Government of India - Ministry of Railways Research, Designs & Standards Organization, LUCKNOW - 226011

MODIFICATION SHEET NO. RDSO/2009/EL/MS/0385 (Rev.0), Dated 15.12.2009

Partial blocking of opening duct of back side of auxiliary converter of three phase electric locomotives.

Fig-1

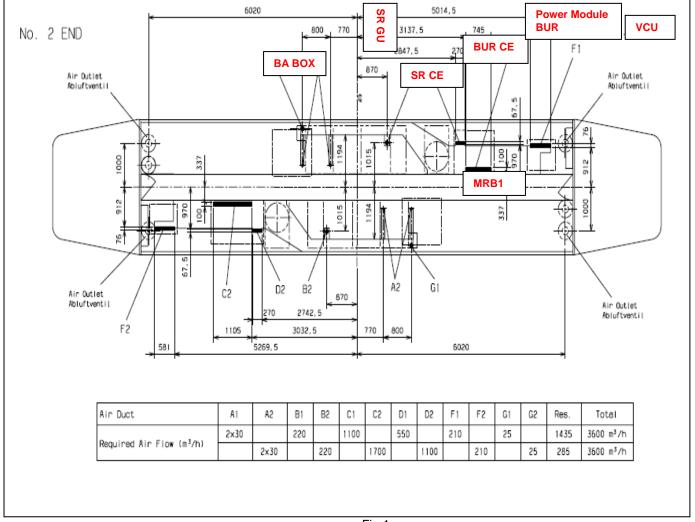
RDSO conducted the measurement of air flow at the various locations of duct outlet in MRB-1 circuit (fig-1) by removing traction converter, auxiliary converter and vehicle control unit in one imported locomotive (loco no. 31015) at Electric Loco Shed, GMO and in one new loco at CLW. The measurements are summarized in table-1

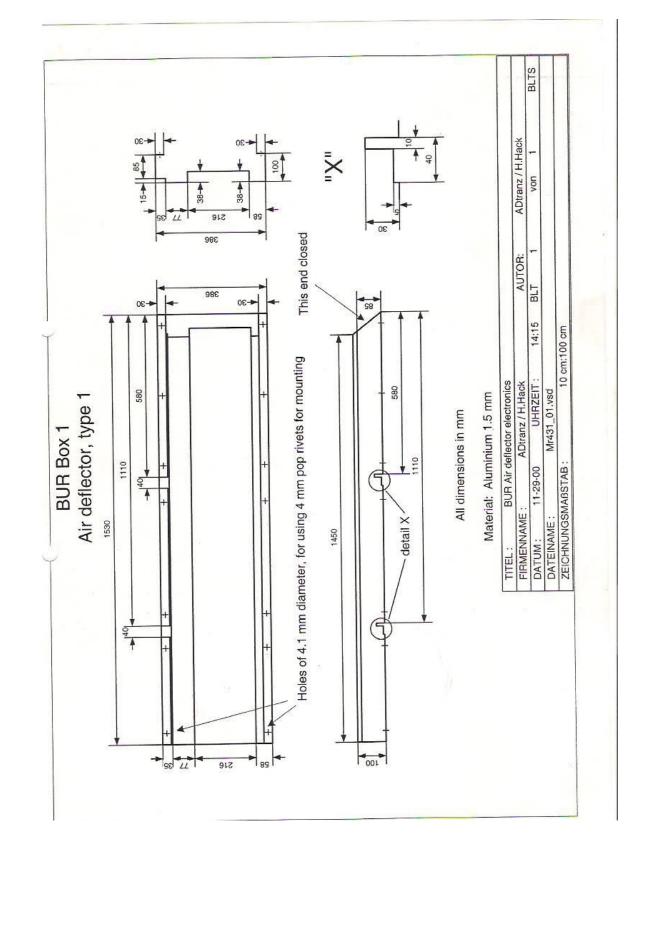
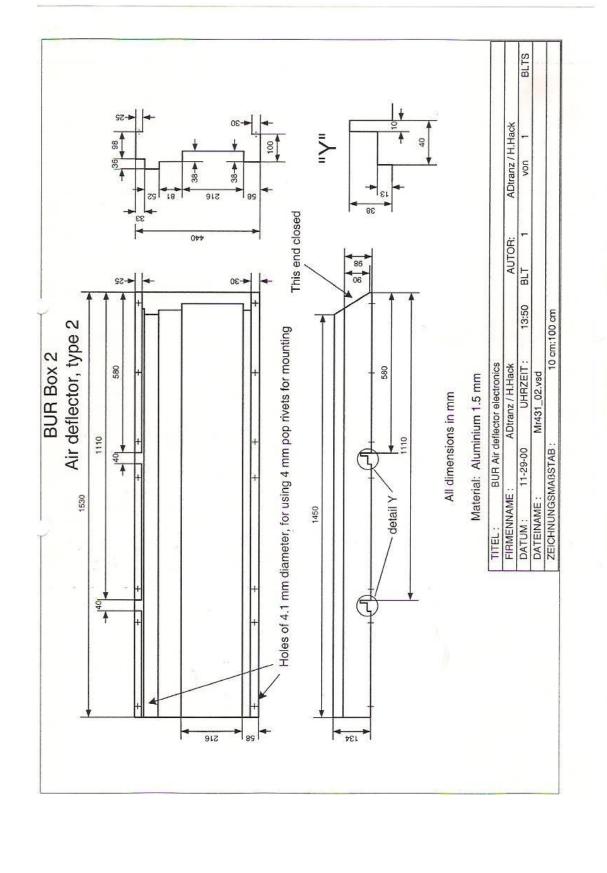
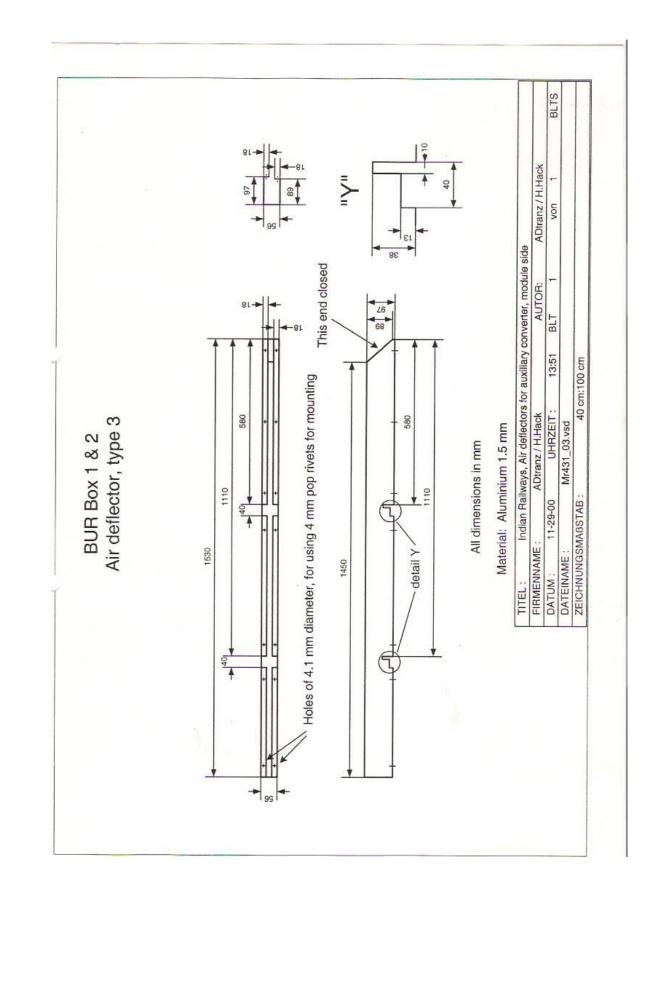
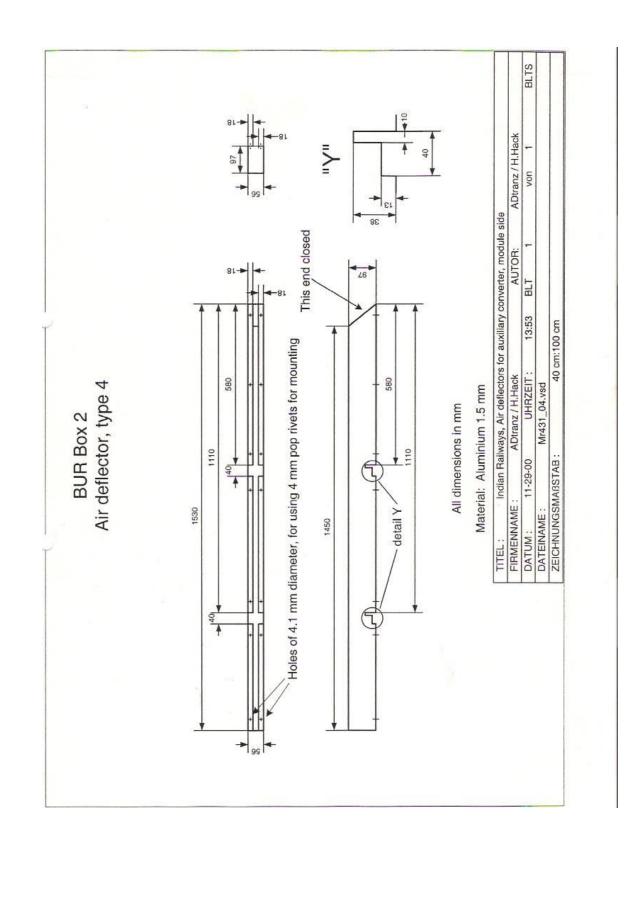
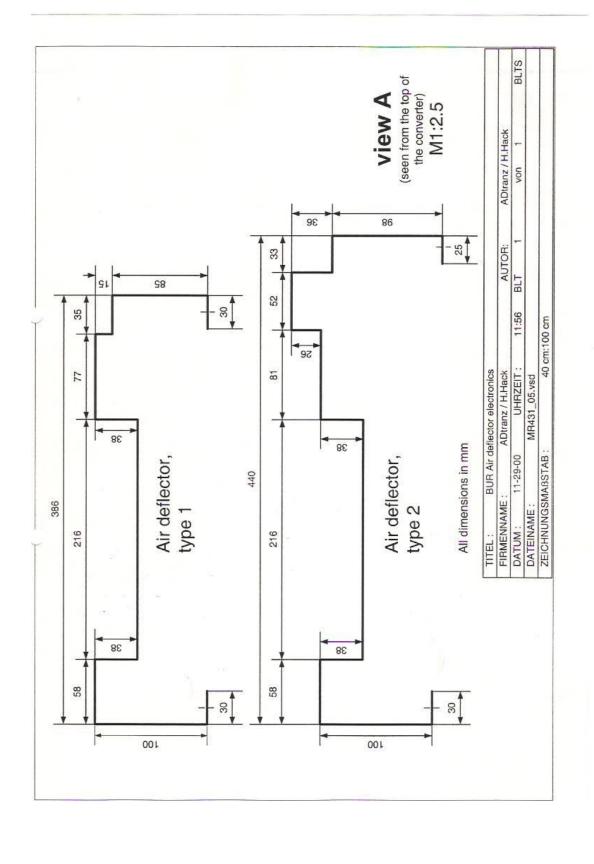
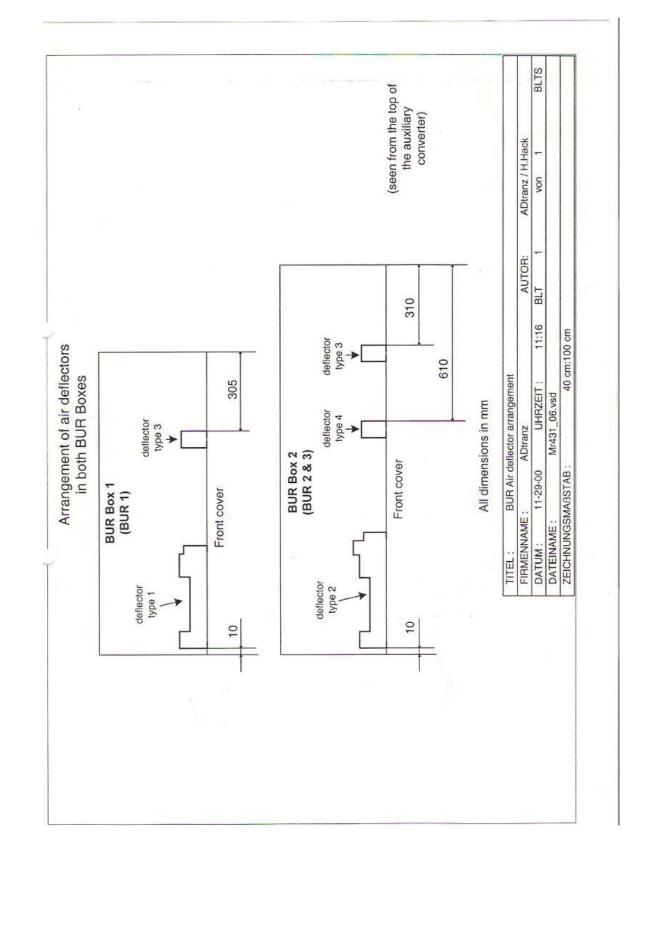
Air flow measurements on the locomotives have shown, that the cooling air flow through the heat exchangers on the auxiliary converter modules is not proper maintained.

In order to increase the air speed through the heat exchangers, additional deflectors have to be installed on the auxiliary converter covers.
